Project	IEEE 802.16 Broadband Wireless Access Working Group < http://ieee802.org/16 >	
Title	Proposal to allow Extended Type subheaders for connections where ARQ is not enabled	
Date Submitted	2004-04-28	
Source(s)	Rehan Jalil Tassos Michail Mano Vafai Aperto Networks 1637 S. Main St., Milpitas, CA 95035, USA	Voice: + 1-408-719-9977 Fax: + 1-408-719-9970 mailto:rjalil@apertonet.com mailto:tmichail@apertonet.com mailto:mvfai@apertonet.com
Re:	802.16REVd/D4 Sponsor Ballot	
Abstract	The document proposes to allow the use of extended subheader type for connections where ARQ is not enabled.	
Purpose	To adopt the proposed changes during comment resolution procedure for sponsor ballot recirculation of 802.16-REVd/D4.	
Notice	This document has been prepared to assist IEEE 802.16. It is offered as a basis for discussion and is not binding on the contributing individual(s) or organization(s). The material in this document is subject to change in form and content after further study. The contributor(s) reserve(s) the right to add, amend or withdraw material contained herein.

Proposal to allow Extended Type subheaders for connections where ARQ is not enabled

*Rehan Jalil, Tassos Michail, Man

Figure 1: Example of incorrect reassembly for non-ARQ connection using 3-bit FSN

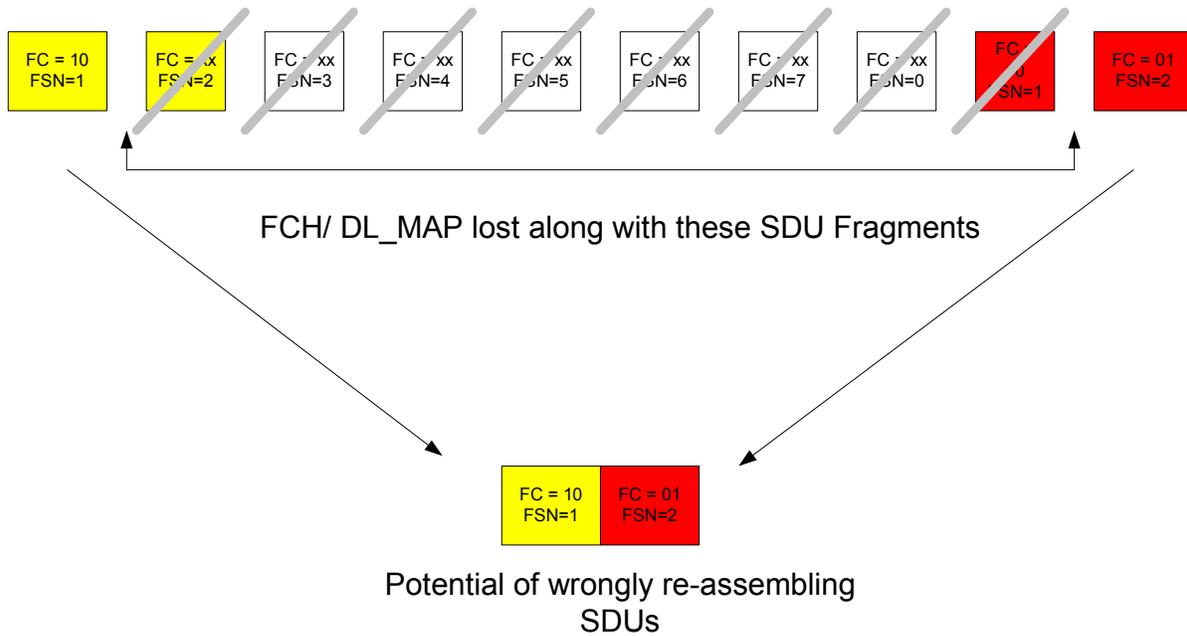
We next illustrate with an example how incorrect reassembly of an SDU may occur if a 3-bit FSN is used. In the scenario shown in Figure 1, 8 consecutive fragments are lost due to a lost FCH/DL-MAP and as a result the FSN wraps-around and causes incorrect reassembly. Given that Ethernet frames do not have CRC, such errors would cause significant performance degradation of upper layer protocols (such as TCP, UDP etc).

In this section we propose some changes to the working group document (P802.16-REVd/D4) to allow the use of the Extended Type for connections where ARQ is not enabled. **The rationale is that 11-bit FSN practically eliminates the probability of the scenario shown in Figure 1.**
